# 1997 Corvette: Service Bulletin: Erratic Fuel Gauge Readings

**Number:** 73-83-22

**SUBJECT: ERRATIC FUEL GAUGE READINGS (REPAIR PINCHED WIRES)**

**MODELS:** 1997 CHEVROLET CORVETTE

**Figure 1**

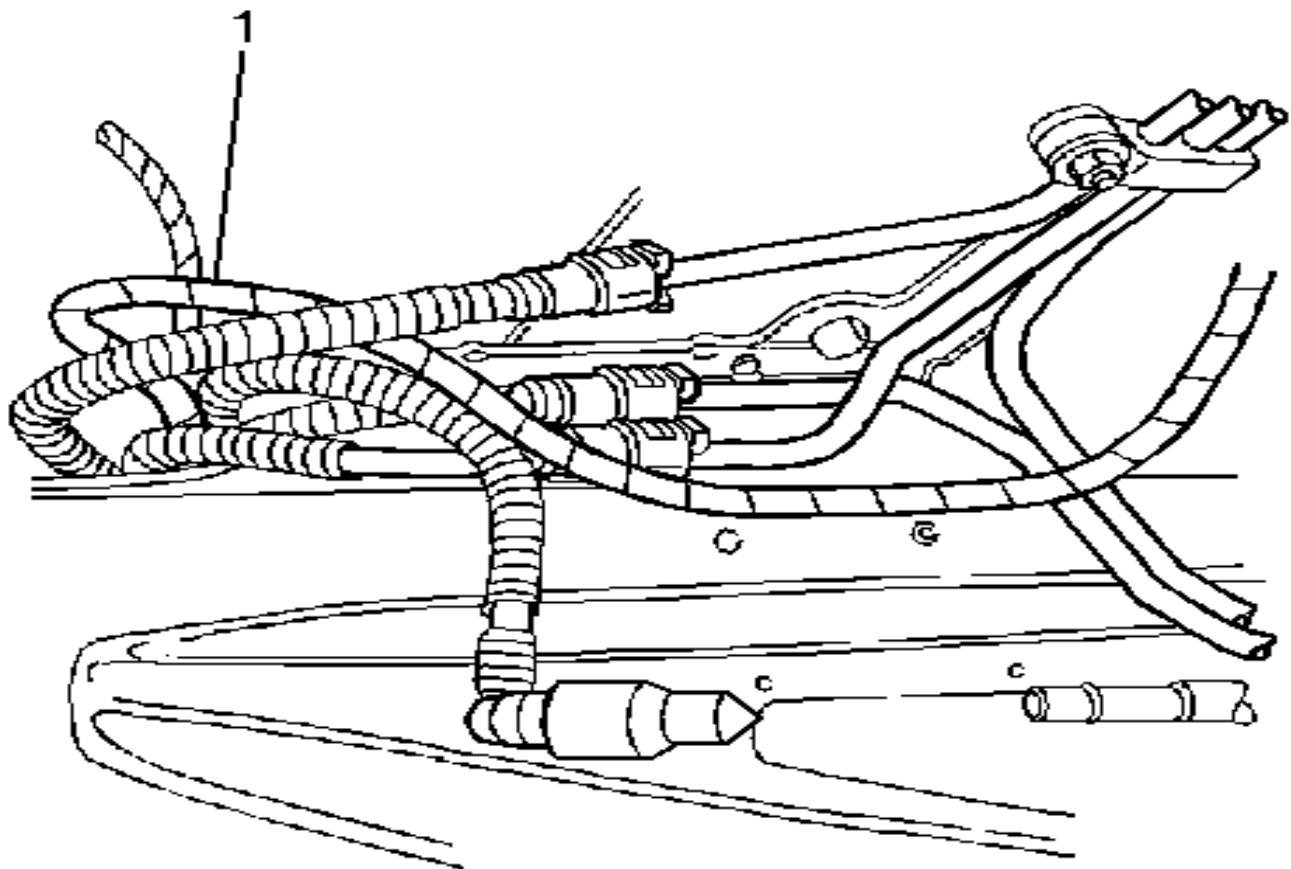
SOME OWNERS MAY COMMENT ON ERRATIC READINGS FROM THE FUEL GAUGE.

THE SENDER WIRES FROM EITHER TANK MAY BE TRAPPED UNDER THE FUEL OR EVAPORATOR LINES WHERE THE LINES ROUTE BETWEEN THE BODY AND THE FRAME RAIL IN THE REAR.

INSPECT THE AREA ABOVE FOR PINCHED WIRES. IF THE WIRES DO NOT MOVE FREELY, THEY MAY BE PINCHED. THE HARNESS IS #1 IN FIGURE 1.

REPAIR THE WIRES AS NECESSARY. MAKE SURE THAT THE WIRES ARE PROPERLY ROUTED, AND MOVE FREELY, TO INSURE THAT THEY WILL NOT BE PINCHED IN THE FUTURE. IT MAY BE NECESSARY TO REMOVE ONE OR BOTH FUEL TANKS FOR ACCESS TO THIS AREA. IF SO, FOLLOW THE PROCEDURES ON PAGE 6-970 IN THE SERVICE MANUAL.
